APPENDIX A

Responses to NRC Requests for Additional Information (RAI) RAI 25, 31 and 39

Figure 1: Leuenberger 80 Sand LPW-1 Pumping Well Drawdown

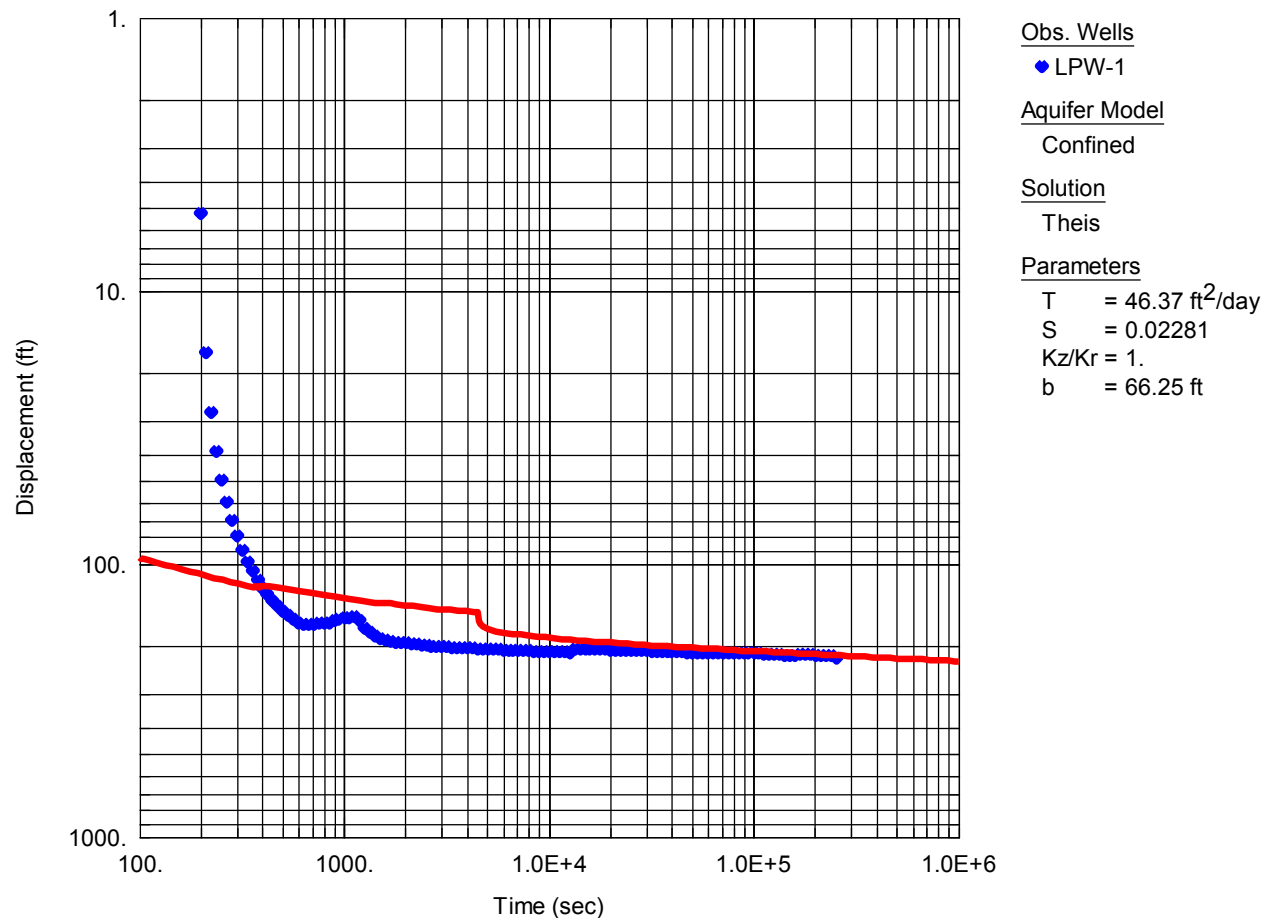
Uranium One should provide traditional time drawdown curves on semi-log time scale for all observation wells for both the 80 and 90 sands aquifer tests at the Leuenberger Satellite. Uranium One should also provide recovery curves on semi-log time scale for the pumping well and the observation wells. Please analyze all curves for transmissivity and storage coefficient and provide these values. If any boundary effects or leakage are noted, describe and reassess the hydrogeologic characteristics of the 80 sand and 90

The updated results for the Leuenberger 80 Sand using data acquired from pumping well LPW-1, shows a T value of 46.37 ft²/day; an S value of 0.0228; and a K value of 0.70 ft/day. The updated results for the Leuenberger 90 Sand using data acquired from pumping well LPW-2, shows a T value of 131.10 ft²/day; an S value of 0.0576; and a K value of 2.70 ft/day. The updated results for the North Platte 70 Sand using data acquired from pumping well LPW-3A, shows a T value of 36.79 ft²/day; an S value of 0.0393; and a K value of 0.99 ft/day. The updated results for the Peterson 90 Sand using data acquired from pumping well LPW-4, shows a T value of 34.73 ft²/day; an S value of 0.0212; and a K value of 0.93 ft/day (Table 1).

Figure 9: North Platte 70 Sand LPW-3A Pumping Well Drawdown

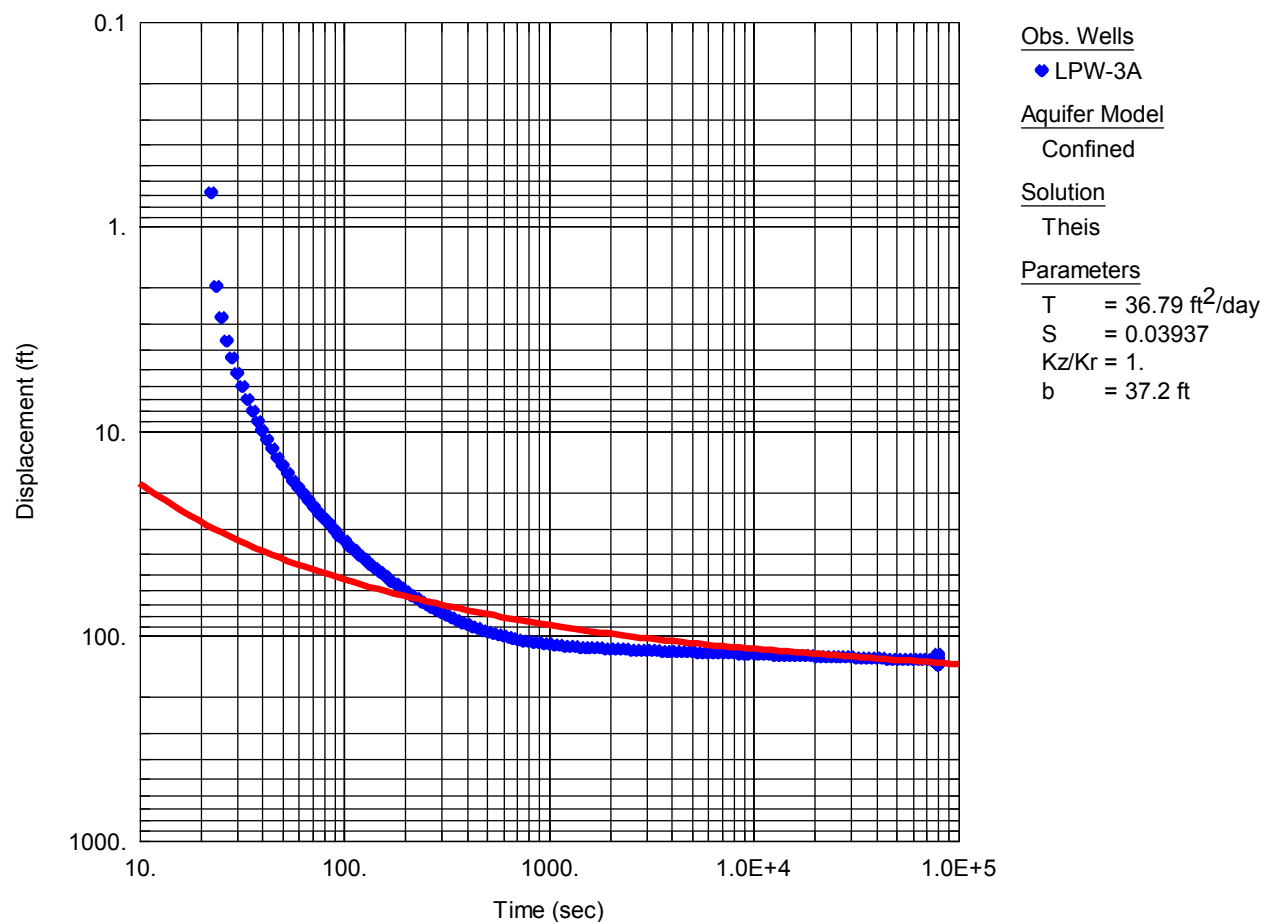
Uranium One should provide traditional time drawdown curves on semi-log time scale for all observation wells for the 70 sand aquifer test at North Platte Satellite. Provide recovery curves on semi-log time scale for the pumping well and the observation wells. In addition, analyze all curves for transmissivity and storage coefficient and provide these values. If any boundary effects or leakage are noted, describe and reassess the hydrogeologic characteristics of the 70 sand at the North Platte Satellite.

The discussion plus Figures 8 through 12 relating to the North Platte 70 Sand pumping well LPW-3A and observation well LMP-5 can be found in this response. Other discussions and figures related to drawdown and recovery of pumping wells and observation wells can be found in the responses to RAIs 25 and 39.

Figure 13: Peterson 90 Sand Pumping Well LPW-4 Drawdown

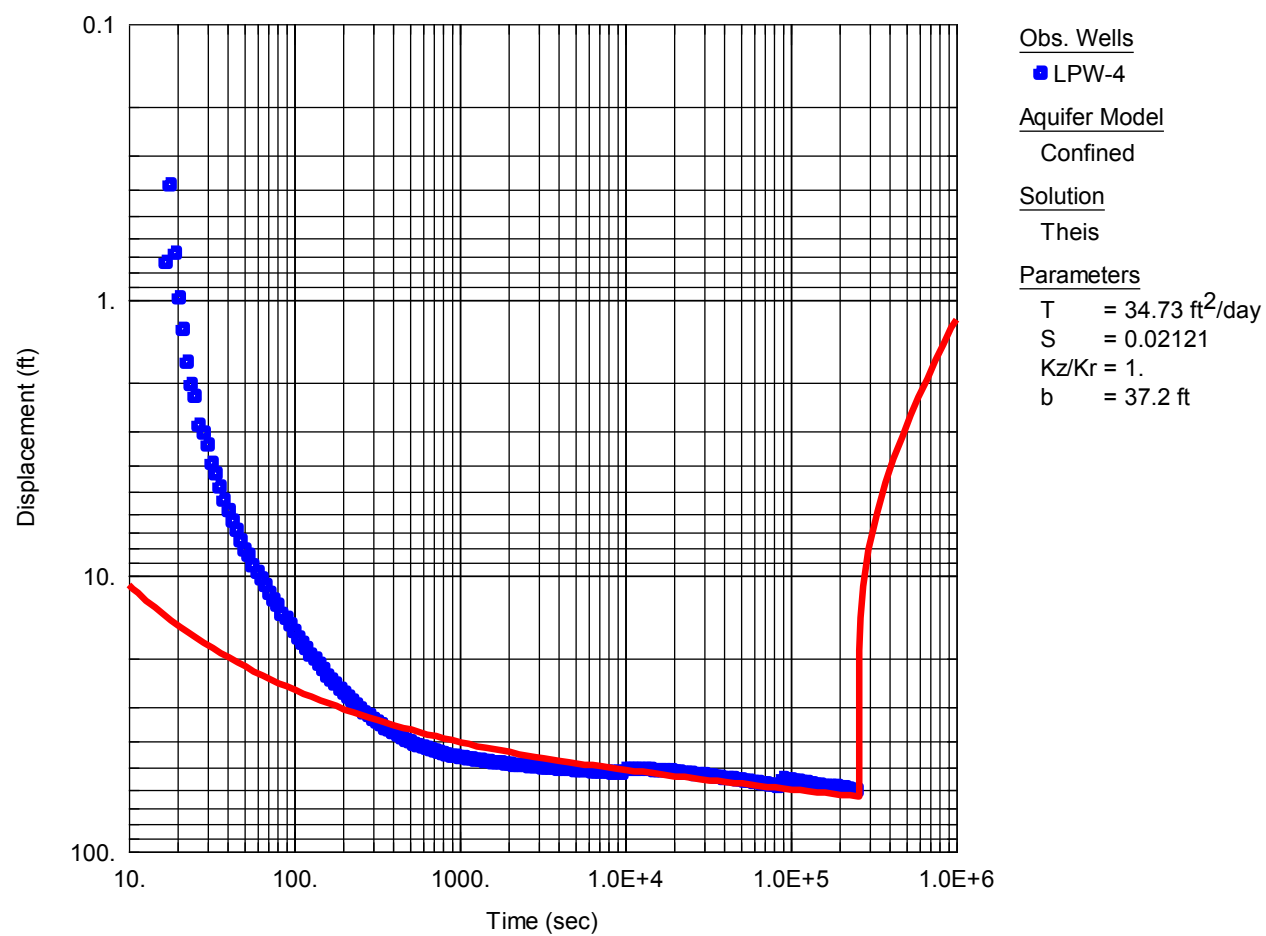
- Provide traditional time drawdown curves on semi-log time scale for all observation wells;*
- Provide recovery curves on semi-log time scale for the pumping well and the observation wells;*
- Analyze all curves for unconfined aquifer behavior;*
- Provide transmissivity, specific yield and storage coefficient values from the analysis for all wells; and*
- Describe and reassess the hydrogeologic characteristics of the 90 sand at the Peterson Satellite, if unconfined behavior is demonstrated.*

The following discussion in addition to Figures 13 through 16 relating to the Peterson 90 Sand pumping well LPW-4 and observation well LMP-7 can be found in this response. Other discussions and figures related to drawdown and recovery of pumping wells and observation wells can be found in the responses to RAIs 25 and 31.
